Information Bulletin

I.B. No: 029

Aircraft Type: T67B, T67C Series, T67M, T67M-MkII, T67M200, T67M260 and T67M260-T3A

Title: ADDITION OF "NO PUSH" PLACARD TO ANTI SPIN STRAKES

FIGURE 1

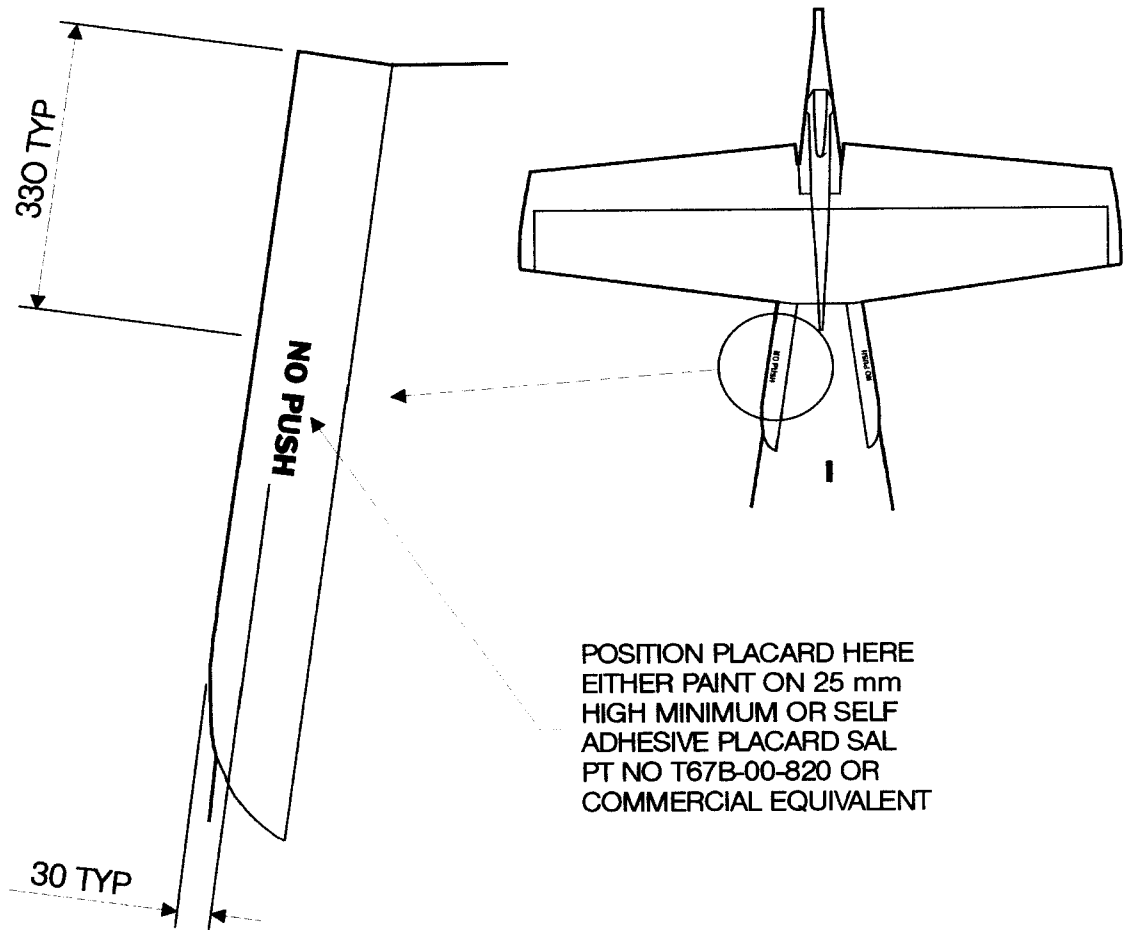
There have been reported cases of cracked anti spin strakes. This has been caused whilst ground handling the aircraft. The strakes are not designed to be used for handling.

It is essential that the strakes are not to be handled and a "NO PUSH" placard is to be painted on or fitted as indicated by Figure 1. A suitable placard is available from SAL as Part No. T67B-00-820. The implementation of this modification is to be annotated in aircraft logbook as "Mod M1003 incorporated".

The strakes are to be inspected for cracking. If cracks are found, then they are to be investigated and if necessary repaired and/or re-painted in accordance with the T67 GRP Repair Manual.
